**Dear Editor,**

**Dear Referee 1,**

**Figure A1. Two-layer modelling of a subaerial/submarine landslide (from the original sketch of Pakoksung et al., 2019), (a) pre-failure, (b) generation of negative and positive waves due to the landslide and (c) landslide in progress and wave propagation.**

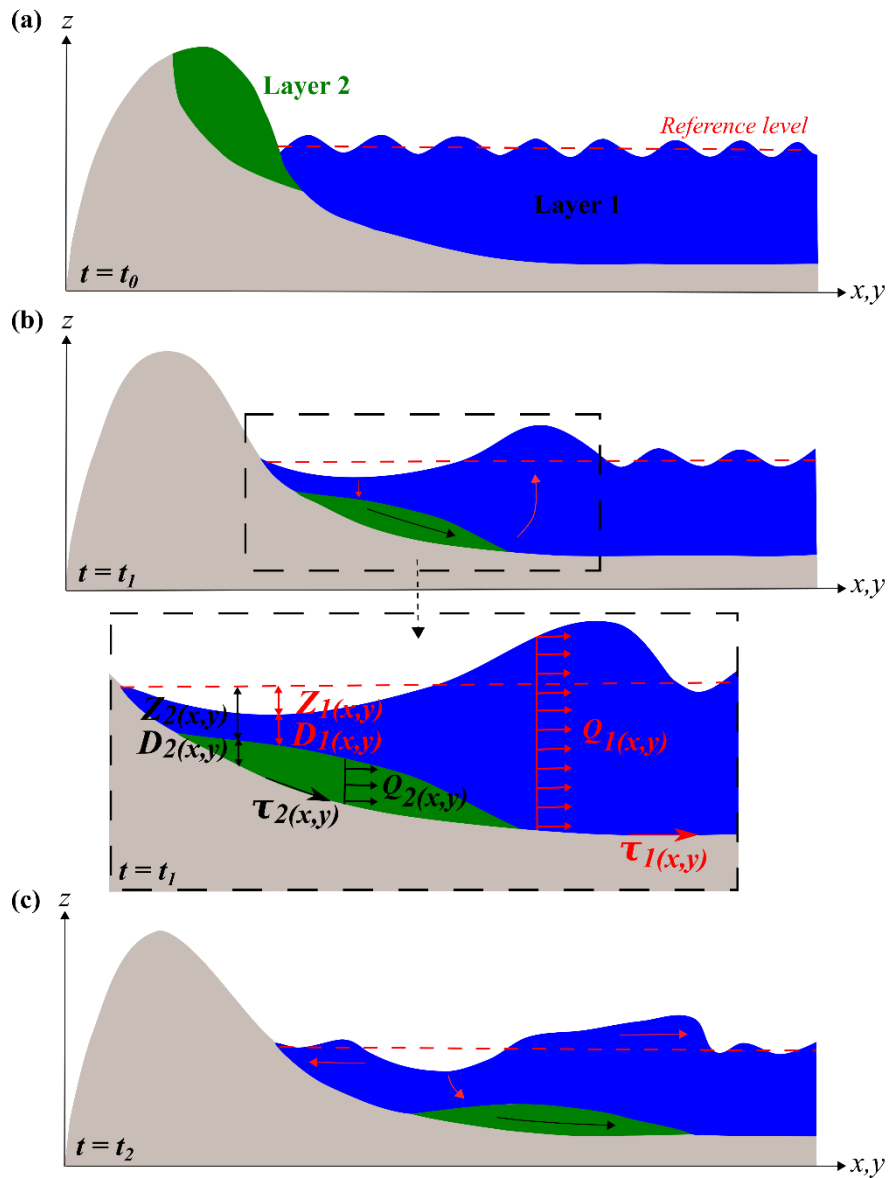
Reviewer comments	Our answers	Corrected manuscript
In Section 3.1.1, the two-layer model is explained. Can the authors explain more on how physically the layer 1 and layer 2 interact? From the equations, the interacting aspects of the two layers are expressed in terms of the water level gradients Z1 and Z2. So the flux Q1 in layer 1 is fluid, while the flux Q2 in layer 2 is soil mass? A figure would be useful addition for this section.	The flux Q1 is water while the flux Q2 is granular material (soil). We added more explanations and Fig. A1 to better understand the meaning of each term.	<b>Line 167:</b> $\rho_1$ and $\rho_2$ are the densities of the seawater and the landslide. <b>The fifth term of the momentum equations (Eqs. 2, 3, 5, 6) represents the interaction between the two layers.</b> The tsunami model...  <b>Line 170:</b> ..., respectively ( <b>Fig. A1 - Appendix A</b> )  <b>Please, see Fig. A1 below (Appendix A).</b>

Figure 2. (a,c) Computational areas (1-3) in the Sunda Strait and Palu-City, magnified view of the building occupation ratio (b) in the Sunda Strait (20-m resolution) and (d) Palu-City (1-m resolution) (background ESRI and © Google Maps).

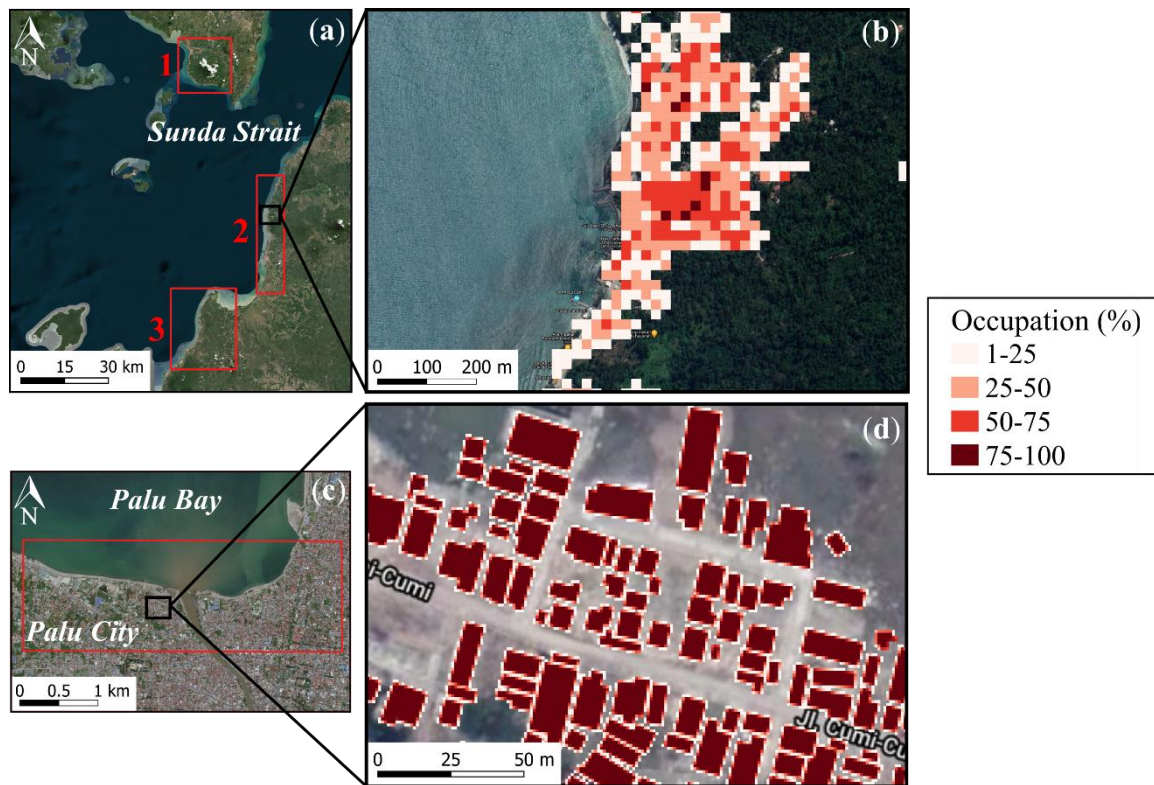
Figure 2 and Section 3.1.2: It is not clear how the computational cells that correspond to buildings (Figure 2d)	The computational cell corresponding to buildings can be inundated by the $n$ Manning coefficient through the last term of	<b>Line 193:</b> ...using GIS data. <b>The computational cell corresponding to buildings can be inundated by the <math>n</math> Manning coefficient through the term <math>D</math>,</b>

<p>Page 6, Eq. 7 ff.: In equation 7 is <math>d</math> a constant? Please define <math>\theta</math>.</p>	<p>We are sorry for this oversight. We corrected it. <math>d</math> is a constant.</p>	<p><b>Line 189:</b> <math>n_o</math> corresponds to the Manning's roughness coefficient (<math>n_o = 0.025 \text{ s.m}^{-1/3}</math>), <math>C_D</math> represents the drag coefficient (<math>C_D = 1.5</math> (Federal Emergency Management Agency (FEMA), 2003)) and <b>the constant <math>d</math> signifies the horizontal scale of buildings (~15 m). <math>\theta</math> is...</b></p>
<p>Page 7, figure 2: It is not clear what the building occupation ratio is. Please introduce a definition. What do the polygons in 2(d) represent? Please add a legend. Are those cells 100% covered? What about the rest of the layer? 0% occupation? Please clarify!</p>	<p>We are sorry and corrected it. Through GIS, we delimited each building, then we computed the building occupation ratio over a pixel (20x20 m<sup>2</sup> in Sunda Strait and 1x1 m<sup>2</sup> in Palu-City). We defined the building occupation ratio as the building area per pixel. In non-residential areas (building occupation ratio = 0 %), we set the Manning's roughness coefficients inland and on the seafloor to 0.03 and 0.025 respectively, which are typical values for vegetated and shallow water areas (Kotani, 1998). In Figure 2d, the polygon corresponds to 1x1 m<sup>2</sup> pixels with an occupation ratio of 100 % (dark red pixels).</p>	<p><b>Line 192:</b> <math>\theta</math> is obtained by computing the building area over each pixel using GIS data. The computational cell corresponding to buildings can be inundated by the <math>n</math> Manning coefficient through the term <math>D</math>, which represents the simulated flow depth (m). In the urban areas of Sunda Strait and Palu, the average occupation ratios are 24 % and 84 % respectively (Fig. 2b,d). <b>In non-residential area, we set the Manning's roughness coefficients inland and on the seafloor to 0.03 and 0.025 respectively, which are typical values for vegetated and shallow water areas (Kotani, 1998).</b></p> <p><b>Please, see the revised Fig. 2 below.</b></p>

<p>can be inundated or not in tsunami simulation.</p>	<p>Eq (7): <math>D</math>, which represents the simulated flow depth (m).</p>	<p>which represents the simulated flow depth (m). In the urban...</p>
<p>In Section 3.2: could you comment on the vertical accuracies of the DEM/DSM used for the investigations? How were they derived? I would guess local LiDAR data?</p>	<p>Corrected.</p>	<p><b>Line 180:</b> BATNAS and DEMNAS, Indonesia, provided the bathymetric and topographic data with 180 and 8 m-resolutions, respectively. The data was established from SAR images (<a href="http://tides.big.go.id/DEMNAS/index.html">http://tides.big.go.id/DEMNAS/index.html</a>). Both datasets were resampled to three computational domains with a grid size of 20-m resolution (Fig. 2a,b). In Palu-City, the bathymetric and topographic data with 1-m resolution were obtained through Lidar images and supplied by the Agency for Geo-spatial Information (BIG), Indonesia (Fig. 2b,c). For tsunami inundation...</p> <p><b>Line 211:</b> To correct the Digital Surface Model (DSM), we removed the vegetation, buildings and infrastructures elevations based on the linear smoothing method and used the resulting Digital Elevation Model (1<sup>st</sup> DEM) as topography in the tsunami inundation model (Fig. 3). The vertical accuracy of the DSM/DEM is about 4 m. The 2018 Sunda Strait...</p>

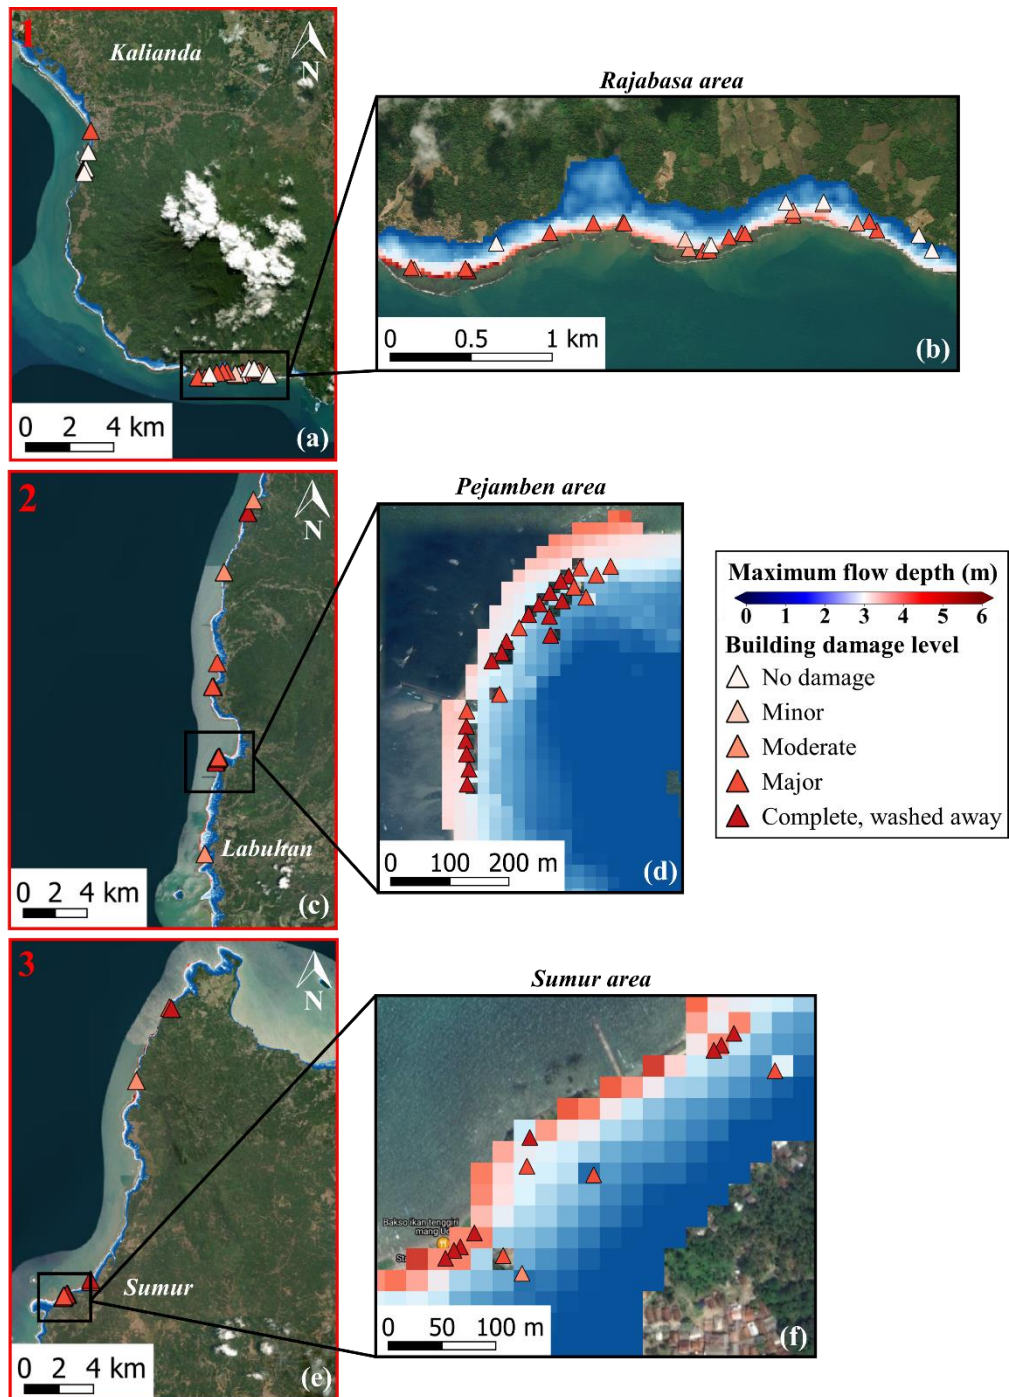
<p>Page 10, figure 5: Do the triangles represent single buildings? It is probably better to choose a representative area on a scale with many surveyed buildings like a city or village instead of large parts of the coast. The figure now does not illustrate well the flow depth close to the buildings. What about the flow velocity plots?</p>	<p>We agreed with the reviewer and added the flow velocity plots in Appendix B. Each triangle corresponds to a single building.</p>	<p>Update of Figure 4 caption: ...to illustrate the topographic corrections applied to the Digital Surface Model (DSM) <b>at buildings (a triangle corresponds to a building), using QGIS</b> (background ESRI and © Google Maps)</p> <p><b>Please, see the revised Figs. 5 and B1 (Appendix B) below.</b></p>
<p>Page 10, line 213: Is landslide S8 oriented towards the city? Isn't that the slide that was captured by the pilot in the departing plane? Isn't the slide direction perpendicular to the bay?</p>	<p>Yes</p>	<p><b>Line 248:</b> ...and (iii) it is close and ideally oriented to Palu-City; <b>the slide direction, captured by an aircraft pilot, is perpendicular to the bay (Carvajal et al., 2019).</b> The density...</p>

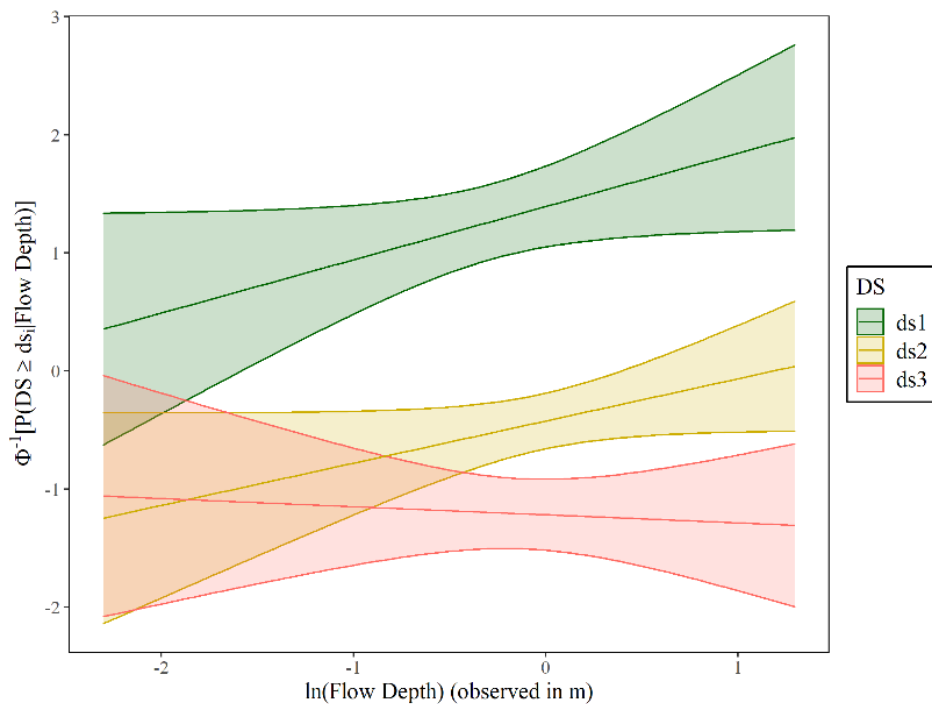
Figure 10 (and other figures as well): Can the data also be displayed? Can the authors clarify the confidence interval indicates the confidence interval of the regression line or the prediction interval of the prediction model? I think by including the data points in Figure 10, this becomes obvious. I think this clarification is important because the number of data is small.	<p>We thank the reviewer for this comment. Figures 10-12, which we believe the reviewer refers to, are part of the exploratory analysis. The sole aim is to show trends in the data which will be useful to construct the statistical model in the following section. All we need to see is whether the intercept and/or the slope of a best estimate curve changes for different variables. For this reason, we use the inverse of the cumulative standard normal distribution in the y axis and the natural logarithm of the tsunami intensity in the x axis. To present the data points will mean to estimate the inverse standard normal cumulative distribution function of the probability that a given building will experience a given damage state or above. For our case, we have building-by-building damage data therefore this probability (e.g., <math>P(DS \geq ds_j   \text{Flow depth})</math>) is either 0 or 1 for which the inverse of the standard normal cumulative distribution function is not defined. For this reason, we did not present the data points. Instead, we updated the text to avoid confusion.</p>	<p><u>Line 319:</u> ... curves. <b>The confidence in the exact shape of the mean curves is estimated and presented in terms of the 90 % confidence intervals around the best-estimate curves.</b></p>

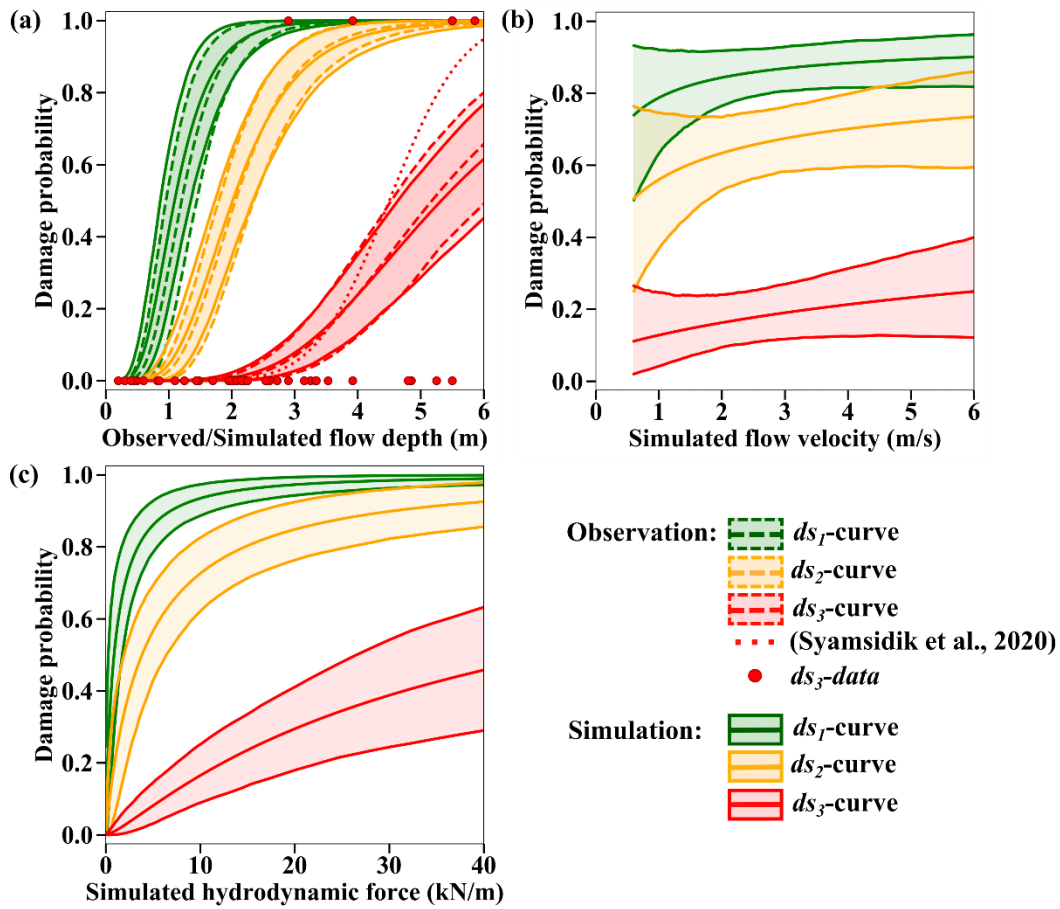
<p>Figure 13: as discussed by the authors, the fragility functions based on flow velocity and (probably) hydrodynamic force do not show realistic features and thus not really useful. It may be useful to show such results for one case but for other cases, they are not really useful, especially for flow velocity. My concern is that careless readers may attempt to use such models as black box models.</p>	<p>We thank and agreed with the reviewer. In the discussion, we discussed whether the tsunami intensity measures are efficient predictors of damage (Section 6.1). The flow velocity and the hydrodynamic force (please, see the drag force formula) are not providing a good description of the tsunami damage, compared to the flow depth. This is a valid contribution to the field. Therefore, the 2<sup>nd</sup> part of the discussion (Section 6.2) is based on the curves function of the flow depth only. Careful readers should rather use fragility curves based on observation as they are of higher quality.</p>	<p><u>Line 172:</u> ... during the tsunami inundation. <b>The hydrodynamic force acting on buildings and infrastructure is defined as the drag force per unit width of the structure (Koshimura et al., 2009).</b></p> $F = \frac{1}{2} C_D \rho u^2 D$ <p><i>C<sub>D</sub></i> represents the drag coefficient (<i>C<sub>D</sub></i> = 1.0), <i>ρ</i> is the water density (<i>ρ</i> = 1000 kg/m<sup>3</sup>), <i>u</i> stands for the current velocity (m/s), and <i>D</i> is the inundation depth (m).</p> <p><b>Please, see the added Section 6.1 and the revised Section 6.2.</b></p>

<p>Page 20, line 416: IO. Please be consistent.</p>	<p>Corrected</p>	<p>Please, see the changes in “Major comments” table.</p>
<p>Page 21, line 434 f.: Here you write: ‘The curves suggest that confined masonry-type buildings have higher performance than timber structures.’ On page 19, line 388: ‘A timber building is found to sustain more damage than a confined masonry one for all damage states.’ Please clarify.</p>	<p>We are sorry and rephrase the second sentence.</p>	<p><u>Line 416:</u> A timber building is found to sustain more damage than confined masonry buildings for the more intense damage states.</p>
<p>Page 22, figure 13: It is unclear which curve was produced by Syamsidik et al. (2020). The red dashed line is</p>	<p>Thank you very much for your suggestions. We only displays the <math>ds_3</math>-data as they are useful for the</p>	<p><b>Please, see the revised Figs. 13-16 below.</b></p>

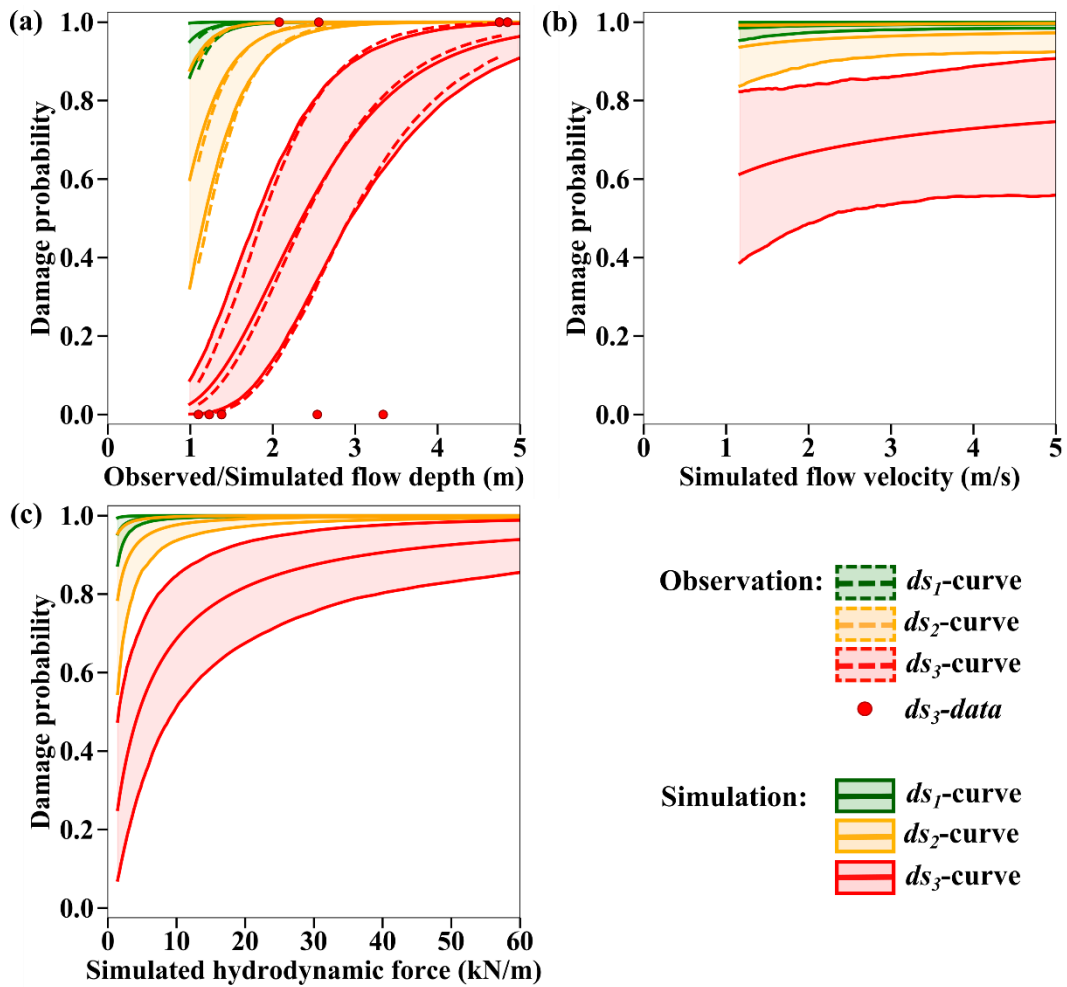
<p>Figure 14: why the data are only shown for x values greater than 1? Should they start with the theoretical constraints that zero fragility for zero hazard values? My concern is again that careless users may take such unrealistic models as they are.</p>	<p>We thank the reviewer for pointing this out. It does not mean that there is no potential damage between 0-1 m flow depths or 0-1 m/s flow velocity. The reason is that we do not have data to predict the shape of the curves.</p>	<p><u>Line 469:</u> ...DB_Sunda2018?. <b>In Fig. 14a,b, there is no data to predict the shape of the curves between 0-1 m and 0-1 m/s. The curves....</b></p>
<p>Figure 15: I understand that the results are based on statistical fitting but these curves do not look realistic. Are they reliable? I think the reliability of the</p>	<p>We agreed with the reviewer. The reliability of the curves is discussed in Section 6.1. Compared to the flow depth, the flow velocity and</p>	<p><b>Please, see the added Section 6.1.</b></p>

<p>Page 23, figure 14: Please consider the comments of figure 13 also for this figure 14. I suggest putting ‘timber buildings’ somewhere in the figure. Maybe in the legend or a figure title. Otherwise, the reader may mix up the figures of confined masonry and timber.</p>	<p>Corrected.</p>	<p><b>Please, see the revised Figs. 13-15 below.</b></p>
<p>Page 24, line 458: Please review and correct the following sentences: ‘The fragility curves based on observation and simulation are similar enough to consider the computed curves as functions of the hydrodynamic features of the tsunami reliable (Fig. 15c,d).</p>	<p>Corrected</p>	<p><u>Line 474:</u> Consequently, the tsunami functions based on observation and simulation are highly similar, which illustrates the accuracy and the reliability of the tsunami inundation model. <b>We also display the curves as functions of the maximum simulated flow velocity in Figs. 13b,14b, and the hydrodynamic force in Figs. 13c,14c.</b></p> <p><u>Line 495:</u> <b>The fragility curves based on the observed and simulated flow depths are relatively similar, especially for <math>ds_1</math> and <math>ds_3</math>. The curves based on the flow velocity and the hydrodynamic force are also displayed in Fig. 15b,c.</b></p>

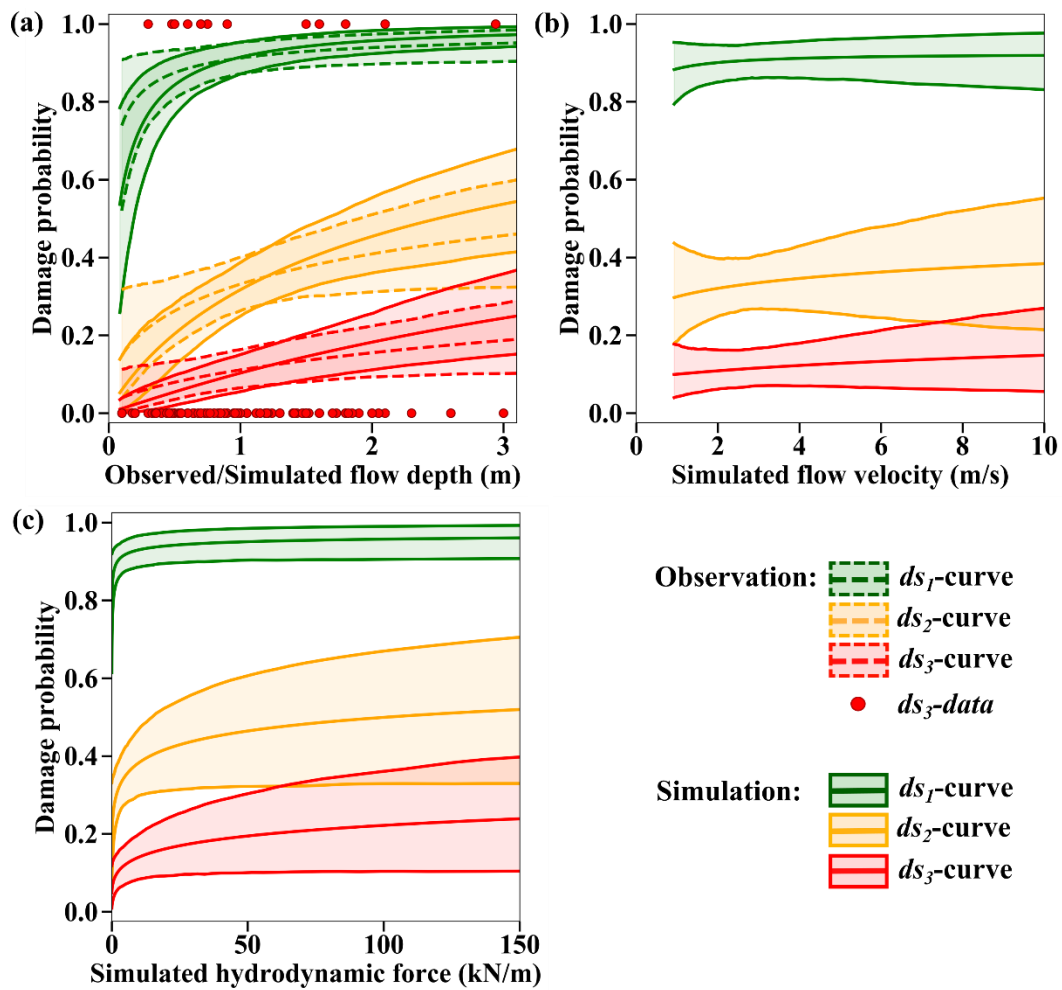
<p>Page 25, figure 15: Please consider the comments for figures 13 and 14 for this figure. I suggest plotting the fragility curves of observed and simulated flow depth in the same graph (hence combine (a) and (b)).</p>	<p>Corrected</p>	<p><b>Please, see the revised Figs. 13-15 below.</b></p>
<p>Page 25, table 11: Why do you use tsunami intensity measure values</p>	<p>As we combine the curves based on the simulated and observed flow depths, we deleted Tables 10 and 11.</p>	<p><b>Please, see the changes in the manuscript.</b></p>
